September 30, 2017

Dear Members of the Zoning Board of Appeal,

Little has changed in the Oct 2 plans for Babcock Place and much is needed to make this project fit into Babcock Street.

**21 TREES LOCATED WITHIN 14' OF THE PROPERTY LINE OF  
134-138 BABCOCK STREET, WHOSE ROOT SYSTEMS WILL BE  
DESTROYED OR SEVERELY DAMAGED BY CONSTRUCTION.  
(BASED ON A SURVEY FROM 9/5/2017.)**

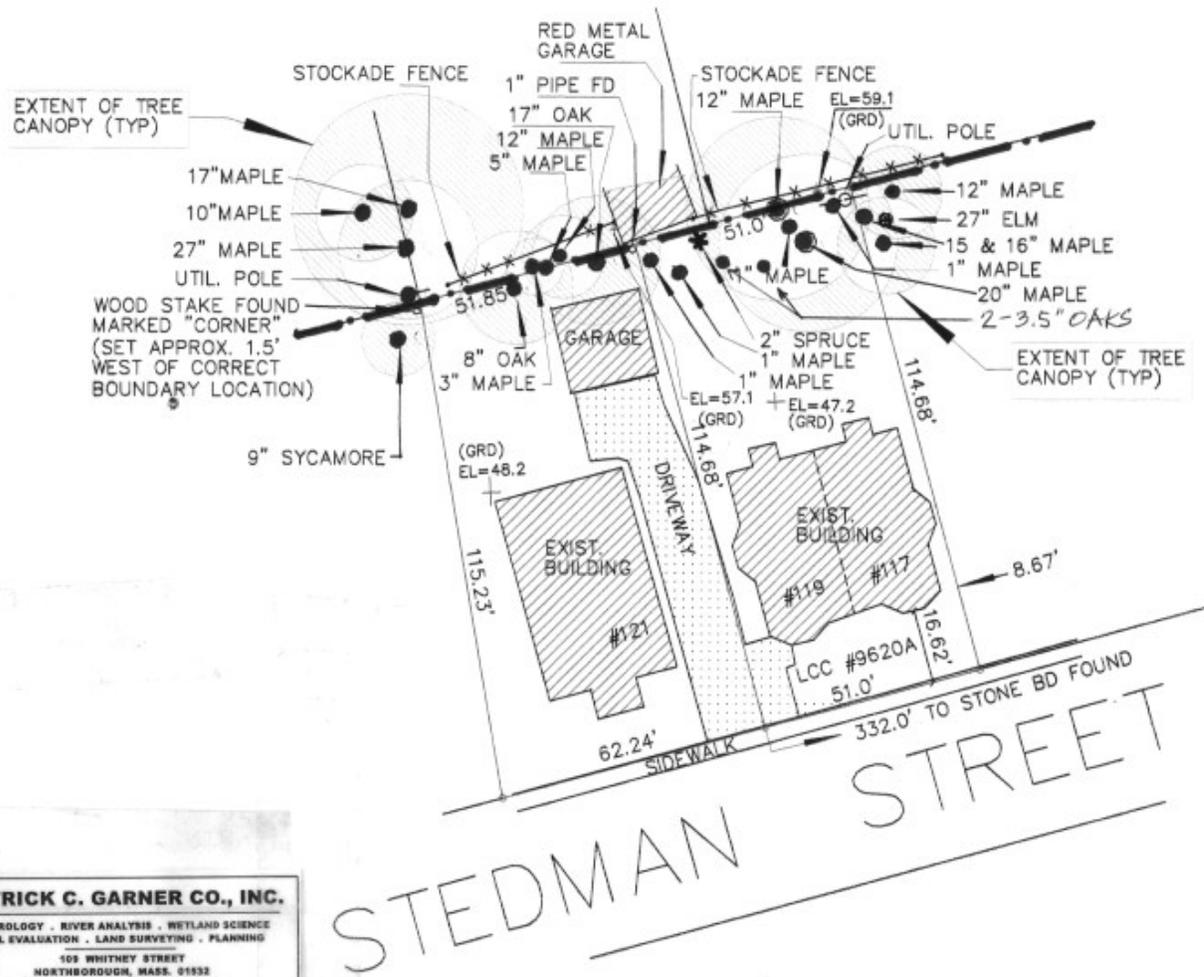
Such a minimal rear setback will not "accommodate vegetative screening between the site and the two-family zoning district" as recommended by the Planning Board. On the contrary it will

degrade and likely destroy the root systems of 21 large trees growing near the rear property line that provide this screening, as well as providing soil stability, habitat, the sequestering of carbon dioxide and release of oxygen. (See Appendices)
